REMARKS

This is a full and timely response to the Office Action mailed November 27, 2007, submitted concurrently with a three month extension of time to extend the due date for response to May 27, 2008.

Objection to the Drawings

FIG.2

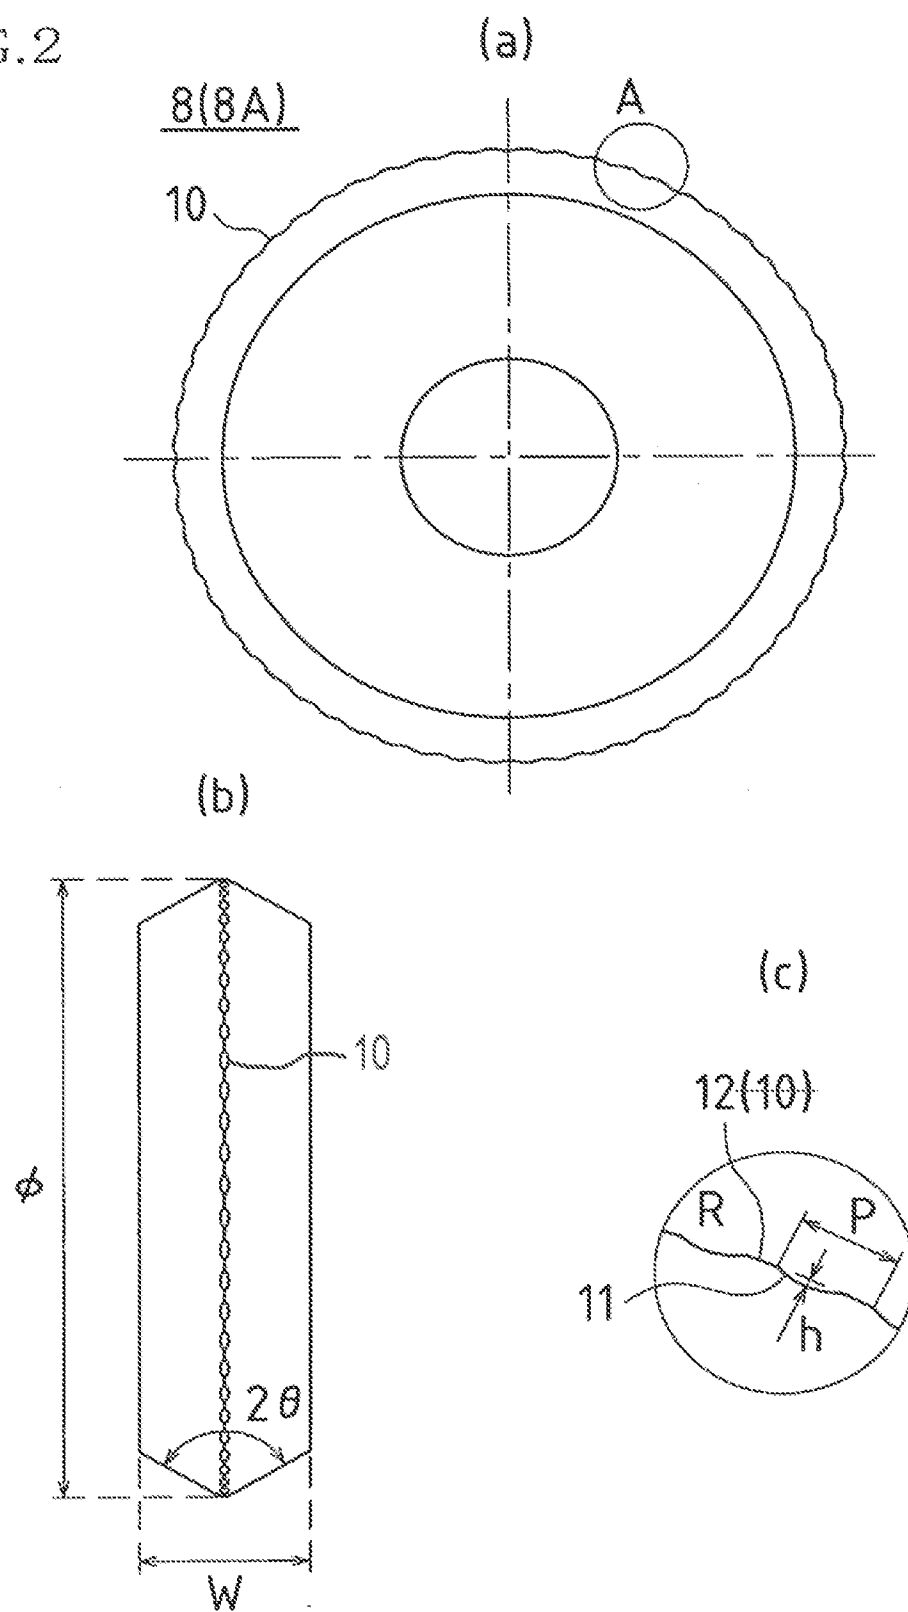
The Examiner has objected to the drawings for (1) lacking clarity in Figures 2(b), 2(c), 4, 5, 6, 7, 8, 10 and 13 and (2) failing to include the figure heading "Prior Art" for Figures 26-29. Applicant has submitted corrected formal drawings which address all of the Examiner's concerns. Thus, withdrawal of this objection is respectfully requested.
